**ALERT SERVICE BULLETIN  
REVISION NOTICE**

**SUBJECT: REVISION "A" TO ALERT SERVICE BULLETIN 427-09-26:  
TAIL ROTOR GEARBOX P/N 406-040-400-ALL AND TAIL ROTOR  
GEARBOX CASE ASSEMBLY P/N 406-040-406-ALL, ONE TIME  
INSPECTION**

NO. 427-09-26

**SUBJECT:** TAIL ROTOR GEARBOX P/N 427-042-400-ALL AND TAIL ROTOR GEARBOX CASE ASSEMBLY P/N 406-040-406-ALL, ONE TIME INSPECTION OF.

Figure 1. Studs and dowel pins location

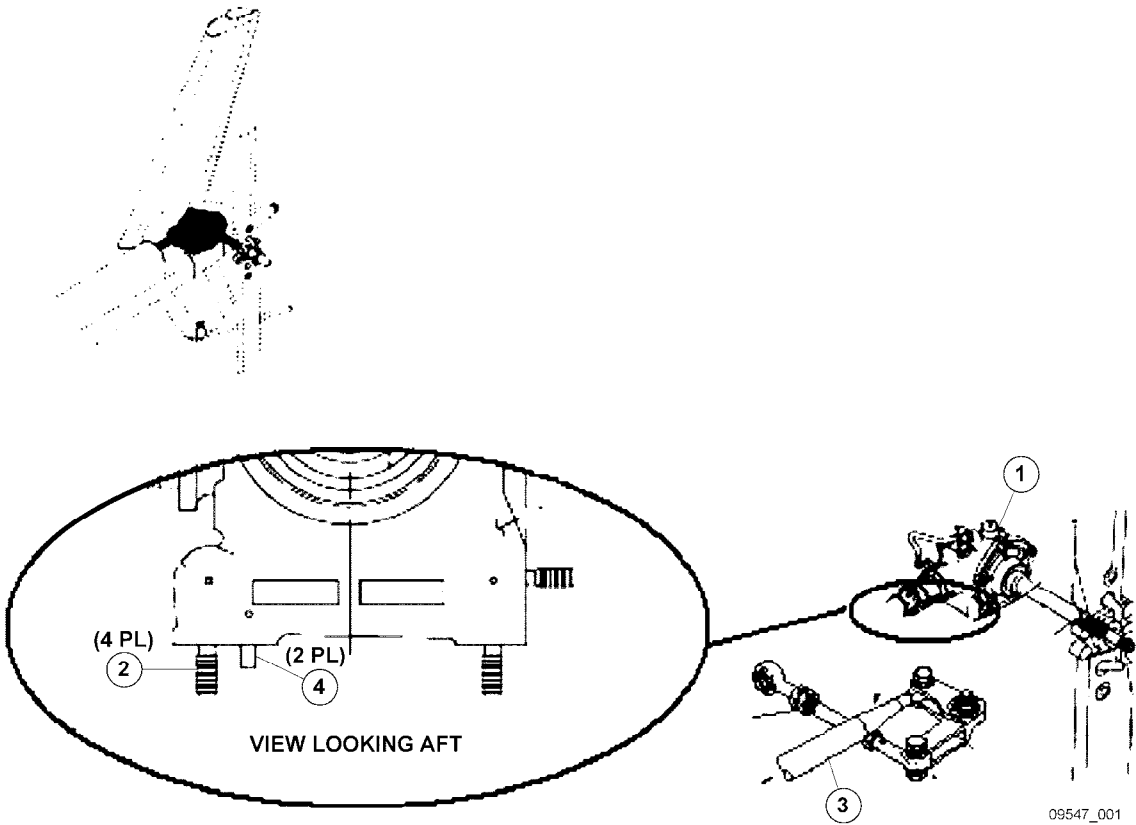
Revision "A" to this bulletin is issued to correct the P/N for the tail rotor gearbox assembly in the subject which should have read **427-042-400-ALL**. In addition, a tolerance of +/- 0.030 inch has been added for the installation of the mounting studs in the gearbox case assembly.

1. Inspect the installation of the four tail rotor gearbox assembly and/or case assembly mounting studs (2, Figure 1). Measure all four studs for proper length. Refer to BHT-427-CR&O, Chapter 65 for stud installation height except the installation tolerance is +/- 0.030 inch.

2. If the length of any of the four studs is not within limit, rework the installation of the defective stud. Refer to BHT-427-CR&O, Chapter 65 for stud installation height except the installation tolerance is +/- 0.030 inch.

3. If the length of all four studs is within limit, proceed to next step.
4. Inspect the installation of the two dowel guide pins (4, Figure 1). Inspect the tail rotor gearbox assembly and/or case assembly to insure that the two dowel guide pins are properly installed and have not become dislodged from the tail rotor gearbox assembly and/or case assembly.

5. If either of the two dowel guide pins are missing or have become dislodged, rework the installation of the dowel guide pin (4, Figure 1). Refer to BHT-427-CR&O, Chapter 65.

1. Using a flashlight and inspection mirror inserted through the side opening in the gearbox support casting. Inspect the forward right hand mounting stud (2, Figure 1) of the tail rotor gearbox (1) for fouling with the directional control tube (3). Refer to BHT-427-MM, Chapter 53.

2. If the directional control tube (3, Figure 1) shows any evidence of fouling with gearbox stud, proceed as follow:
  - a. Remove the tail rotor gearbox fairings and inspect tube for mechanical damage. Refer to BHT-427-MM, chapter 67. Repair tube assembly in accordance with the BHT-427-MM, chapter 67.

3. Using a flashlight and inspection mirror, inspect all four of the tail rotor gearbox mounting studs (2, Figure 1) to ensure that no more than four threads of the stud extend beyond the end of the attaching nut.

4. If more than four threads are exposed beyond the end of attaching nut on any of the tail rotor gearbox mounting studs (2, Figure 1), remove the tail rotor gearbox (1) and rework the installation of the mounting studs. Refer to BHT-427-CR&O, Chapter 65 for stud installation height except the installation tolerance is +/- 0.030 inch.

6. Using a flashlight and inspection mirror, inspect the tail rotor gearbox (1, Figure 1) for proper installation of the two dowel pins (4).
7. If either of the two guide pins are missing or have become dislodged, remove the tail rotor gearbox and rework the installation of the dowel pins. Refer to BHT-427-CR&O, Chapter 65.
